STAFF REPORT
COMMUNITY DEVELOPMENT DEPARTMENT

SUBJECT: Nine Mile Creek Bungalows
[SHP-2023-0003](#)

LOCATION: 2055 S. Locust Grove Road., in the SE ¼ of the SE ¼ of Section 19, T.3N., R.1E.

Short plat to subdivide an existing residential lot (S1119141856), consisting of 1.34 acres of land, into four (4) building lots, one (1) common driveway lot, and one (1) common lot in the R-4 zoning district.

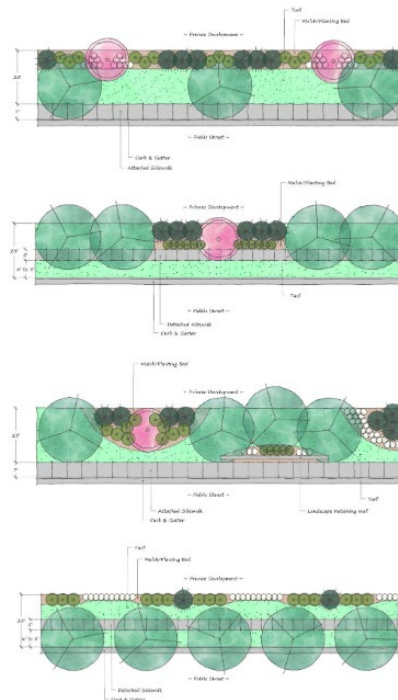
The common lot depicted on the north encompasses the easement for the Nine Mile Creek on a portion of this property. Staff recommends that the proposed 25-foot easement for the landscape buffer along the Locust Grove Street frontage terminate at the shared property line of Lot 4, Block 1, and the northern common lot (refer to the figure below).

- h. Add Note #12: Specify who is to own and maintain the northern common lot.
 - i. Modify the plat to readjust the 25-foot landscape buffer along the street frontage.

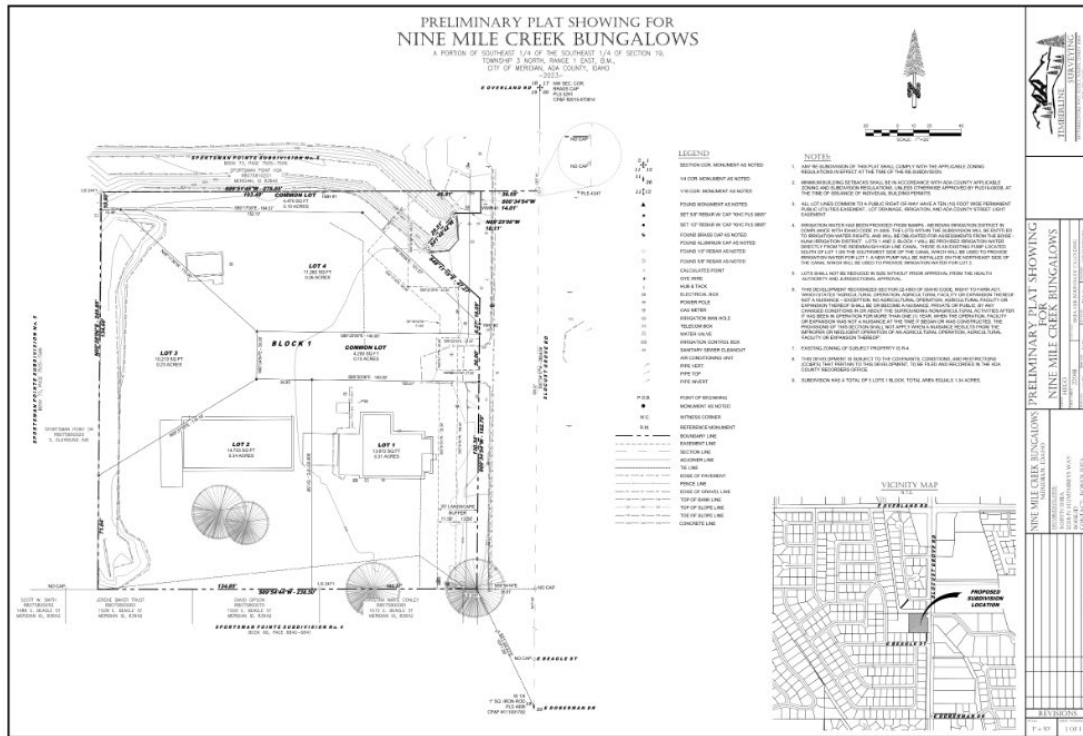
The landscape plan specifies that the use of “weed fabric is not recommended”. **If rock mulch is used, a weed barrier fabric shall be used beneath the rock in accordance with UDC 3B-3.H. Impermeable plastic weed barriers are prohibited because they restrict water and oxygen to the plants. Within stormwater facilities, mulch may not float. Staff recommends that the Applicant install a weed barrier fabric beneath rock mulch as required by the UDC code.**

There are a few existing trees on this site, of which two (2) are proposed to be removed. A mitigation plan was not submitted; however, the landscape plan included in Section VI.B, depicts existing trees that are proposed to be removed vs. retained. **Mitigation should be proposed on the landscape plan in accordance with the standards listed in UDC [11-3B-10C.5](#). The Applicant should provide a description outlining how existing trees to be retained are to be protected during construction. Furthermore, the landscape plan is missing a calculation table for project components, necessary for demonstrating compliance with the UDC requirements.**

- l. Depict the Land Surveyor's signed seal on the plat.
3. Prior to signature on the plat, the landscape plan shall include the following revisions:
 - a. Mitigation shall be required for all existing trees four-inch caliper or greater that are removed from the site with equal replacement of the total calipers lost on site up to an amount of one hundred (100) percent replacement per UDC 11-3B-10C.5

- b. Revise the landscape plan to include a variety of shrubs along with the trees within the landscape buffer along S. Locust Grove Road in accordance with UDC 11-3B-7.

- c. Install a weed barrier fabric beneath the rock mulch in accordance with UDC 11-3B-3H.
 - d. Install fencing along the common lot adjacent to the Nile Mile Creek and remove any prohibited fencing in accordance with UDC 11-3A-7.

C. Aerial Map & Elevations of Existing Home

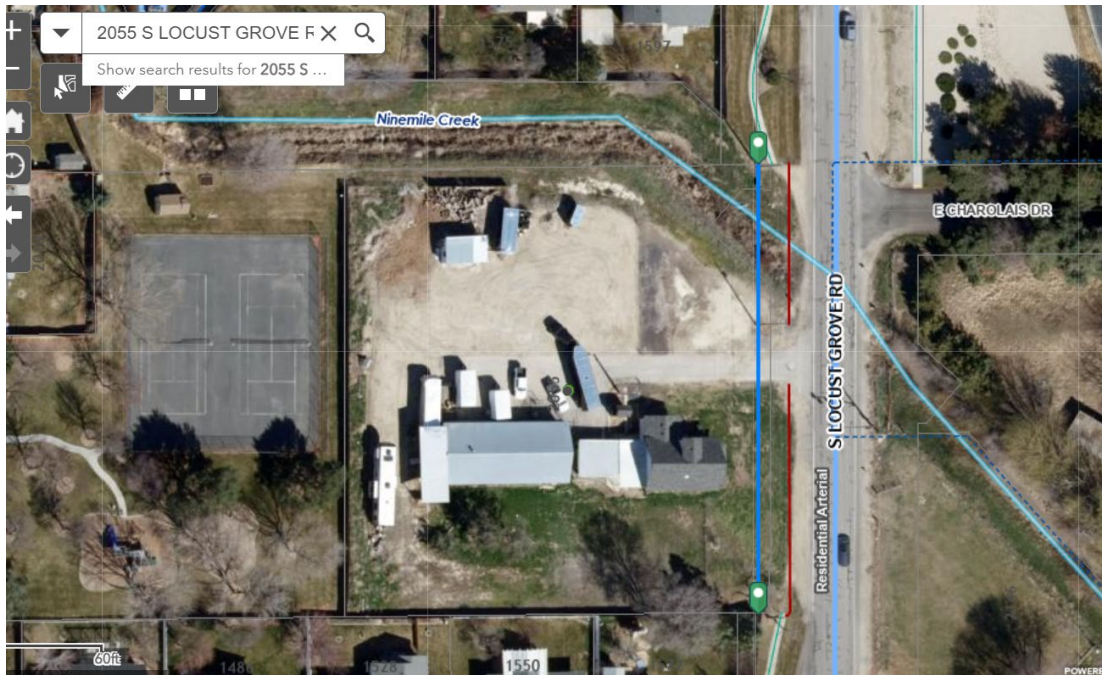
Existing structure: The existing home is connected to City water and sewer service and is proposed to remain on Lot 1, Block 1. The detached garage/shop and accessory structure on Lots 2 and 3 are proposed to be removed upon development of the subdivision. Additionally, the carport for the existing home is proposed to be removed to comply with the rear setback. Once the carport and the detached garage are removed the existing home would not meet the required number of off-street parking spaces. Per [UDC Table 11-2A-5](#), a four-bedroom home must provide four (4) parking spaces, at least two (2) in an enclosed garage, other spaces may be enclosed or a minimum 20-foot by 20-foot parking pad.

By removing the required parking from the property, a CUP may be required per the non-conforming regulations set forth in UDC 11-1B-4, unless the existing garage is retained. At a minimum, staff recommends that the applicant retain the existing carport and install the required parking pad so that in the future a garage could be constructed to avoid having to obtain CUP approval for any expansion. This requires some of the lot lines on the plat to be adjusted to accommodate the carport prior to City Engineer's signature on the plat.

5. As a result of the non-conformity to the existing home due to the off-street parking requirements in UDC 11-3C-6, the Applicant/Owner is required to apply for a Conditional Use Permit for any future expansions on the property. Additionally, the existing carport shall be retained and the Applicant shall install the required parking pad in accordance with UDC 11-3C-6.
